ASME and NRC Discussion on Code Case N-766 Weld Inlay/Onlay Mitigation or Repair

Summary of Remaining NRC Comments

ASME Responses

Recent GE/MRP Data suggests PWSCC rates are lower than used in NRC analysis

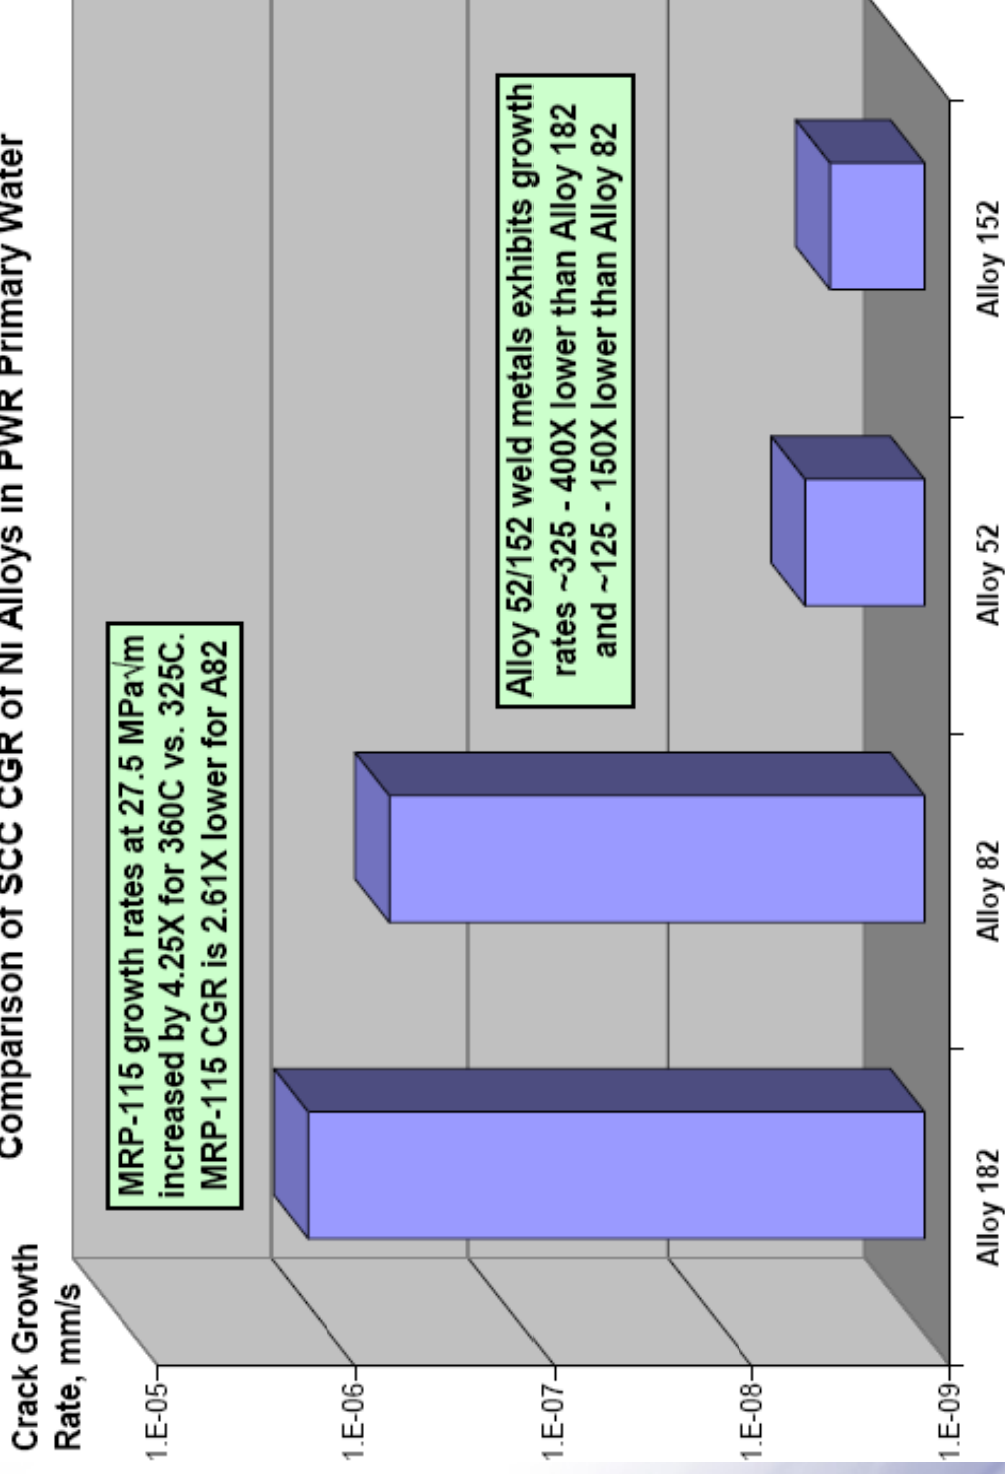
Comments related to ML101260548

- PWSCC growth rates used in ML101260548 are appropriate given the low magnitude of PWSCC rates that has been observed in the Alloy 690 material and weld metals
- Using the Alloy 82/182 rates divided by 100 or $\sim 3.0\text{E-}9$ mm/s (~ 100 $\mu\text{m}/\text{year}$, or 1 to 2 grains per year)
- That CGR is the median rate listed in ML101750347
- Note these rates are very low and by their nature extremely precise experiments and long test durations (e.g. > 6 months) under constant K conditions are required to obtain the data
- Nevertheless, when these low rates are compared to recent, actual constant K crack growth rates, these low measurements may still be conservative
- As more crack growth rate data for Alloy 52/152 becomes available, it is anticipated that the Alloy 52/152 CGR will be in the range equal to the Alloy 182 rates/400
